UNITED STATES
DEPARTMENT OF THE INTERIOR
BUREAU OF LAND MANAGEMENTFORM APPROVED
OMB No. 1004-0137
Expires: March 31, 2007**SUNDRY NOTICES AND REPORTS ON WELLS***Do not use this form for proposals to drill or to re-enter an abandoned well. Use Form 3160-3 (APD) for such proposals.***SUBMIT IN TRIPLICATE- Other instructions on reverse side.**1. Type of Well
☒ Oil Well ☐ Gas Well ☒ Other2. Name of Operator **SOUTHWEST ROYALTIES, INC.**3a. Address
6 DESTA DRIVE, STE 2100, MIDLAND, TX 797053b. Phone No. (include area code)
432/688-32674. Location of Well (Footage, Sec., T., R., M., or Survey Description)
UNIT K, 1980' FSL & 1980' FWL, SEC 19, T26S, R 37E5. Lease Serial No.
LC030168A

8. Well Name and No.
EAVES A #59. API Well No.
30-025-1201110. Field and Pool, or Exploratory Area
SCARBOROUGH; YATES 7 RIVERS11. County or Parish, State
LEA COUNTY, NM**12. CHECK APPROPRIATE BOX(ES) TO INDICATE NATURE OF NOTICE, REPORT, OR OTHER DATA**

EAVES "A" #5
 1980' FWL @ 1980' FWL
 Sec. 19, T-26S, R-37E

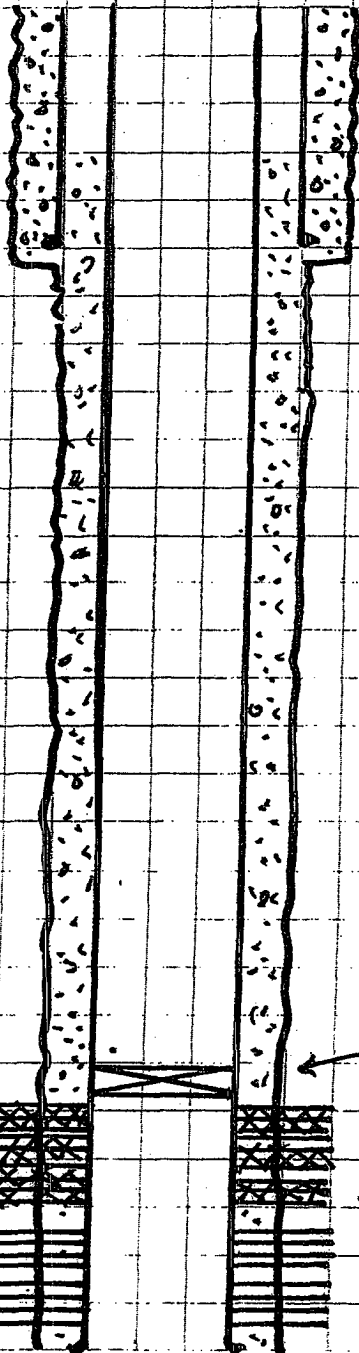
- A. Approval is granted to P/A this well with the following modifications to the program:
- B. Increase the cement volume on top of the CIBP to 40 sacks to cover the base of the salt in addition to the completion and tag.
- C. Set a 25 sack cement plug @ 1320' for the top of the salt and surface casing shoe, tag.
- D. Perforate the casing at 100 feet and fill the annulus and the 5 ½ inch casing to the surface with cement.
